SERVICE BULLETIN

SUBJECT: Norco, Inc. Thrust Reverser Hold Open Rod - Check Inner Rod Retaining Screw

A 2972-78-1

Figure 1

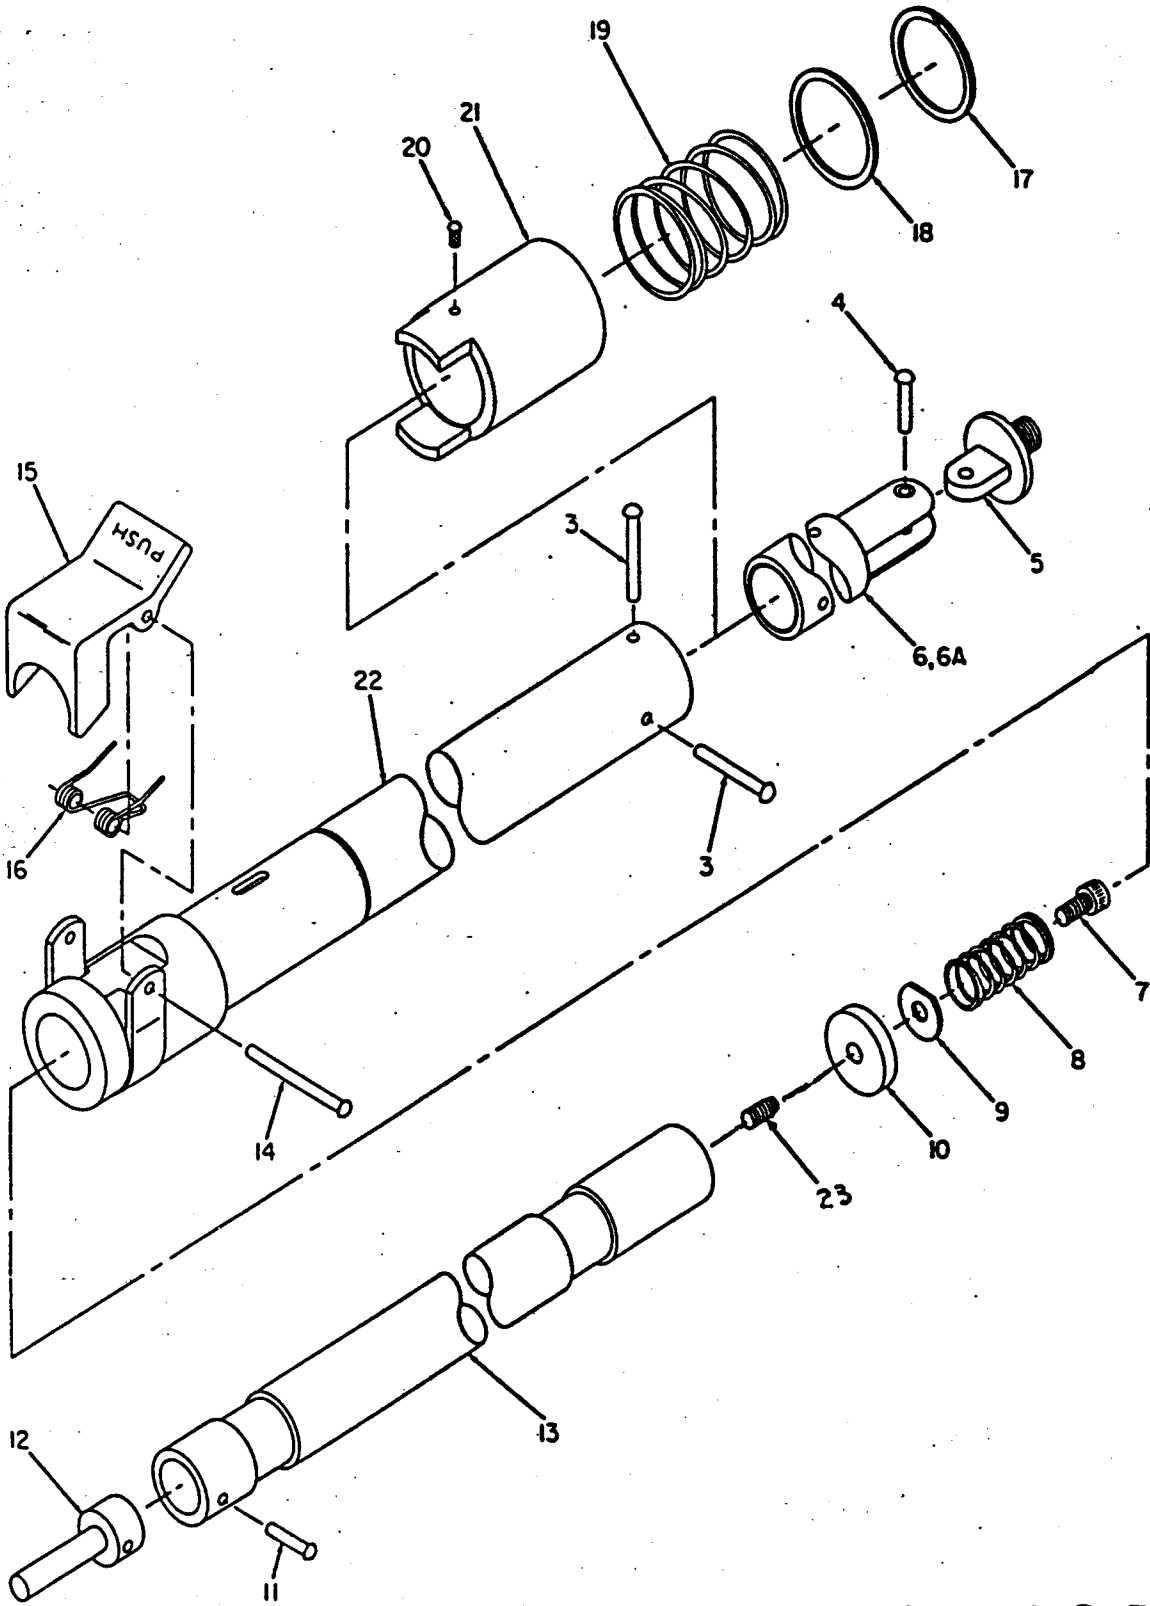
The above serial numbers may be upgraded with larger retaining screw and helicoil insert to prevent the inner rod retaining screw from working free due to vibration or excess force, letting the inner rod be pulled from the assembly.

- 1) Remove the two rivets (3) from the outer tube assembly (22).
- 2) Remove the clevis end plug (6 or 6A), with clevis fitting (5) and rivet (4) attached, from the outer tube assembly (22).

- 3) Push inner rod assembly (13) fully to the rear of outer tube assembly (22).
- 4) While holding end fitting (12) in a soft jawed vice, insert a 5/32 hex wrench into the rear of tube assembly (22). Unscrew and remove socket head cap screw (7) from flat washer (9), spacer (10) and discard these components.
- 5) Remove inner rod assembly (13) by pulling it forward through the front of tube assembly (22).

- 1) Reinstall inner rod (13) through forward end of outer tube (22). Locking lever (15) will have to be depressed in order to obtain access to bore.
- 2) Lock the lock rod assembly (13) retracted. Check that the lock (15) is engaged with the front locking groove of item (13).
- 3) Place the spacer (10) against the rear end of the lock rod assembly (13) in the outer tube assembly (22).

- 4) Insert the flat washer (9) into the compression spring (8), wedging it between the first and second turns at one end of the wire coil.
- 5) Insert the assembled washer (9) and spring (8) -- washer end first -- into the outer tube assembly (22). Press the washer end of the spring (8) against the rear end of the lock rod assembly (13).

- 6) Attach the spring (8), flat washer (9), and spacer (10) to the lock rod assembly (13) by passing the socket head cap screw (7) through items (8), (9), and (10) and threading item (7) into the helicoil insert in the rear end of item.

- 7) Grasp forward portion of inner rod (13) in a soft jawed vice and torque socket head cap screw (7) to 50 in. lbs.
- 8) Fully extend and lock the rod assembly (13). Insert the plug body of the clevis end plug (6 or 6A) into the rear end of the outer tube assembly (22). Align the four rivet holes in the plug body with the four holes for two rivets (3) near the rear end of item (22).

- 9) Respectively insert two rivets (3) through the two sets of four rivet holes in the outer tube assembly (22) and clevis end plug (6 or 6A). If a rivet (3) is a maximum-tolerance diameter, the holes may be enlarged by drilling to no more than 0.162-inch (4.1168-mm) diameters to receive the rivet.

FIG. 2

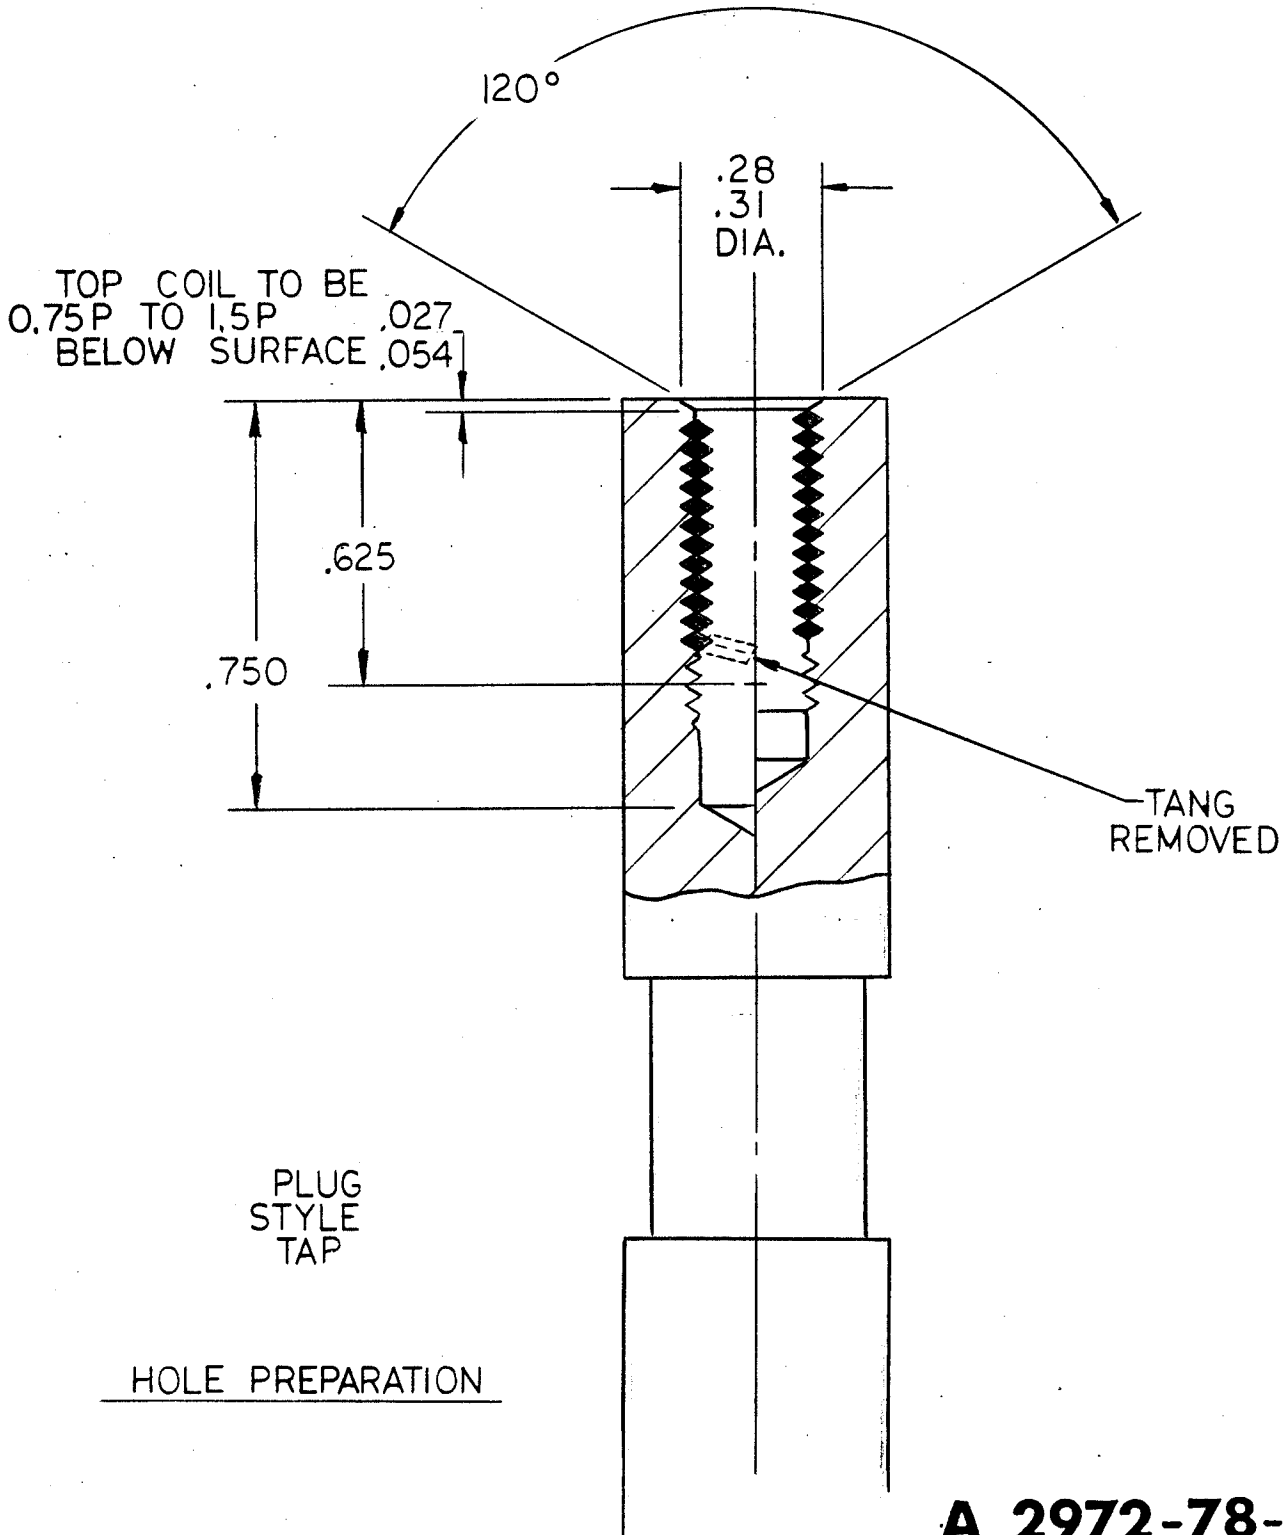
B. Rework Instructions - (See Fig. 2)

- 1) Install inner rod in a lathe so that access to the existing 10/32 threaded hole is available.
- 2) Drill .261 dia. x .750 deep.
- 3) Countersink 120 \pm 5 x .28/.31 dia.
- 4) Tap with helicoil STI Tap #4FPA-H3 x .625 min. full thread.
- 5) Install helicoil screw lock insert P/N MS21209-F4-20 with helicoil tool No. 7552-4.
- 6) Break off driving tang with helicoil tang break off tool #3695-4.
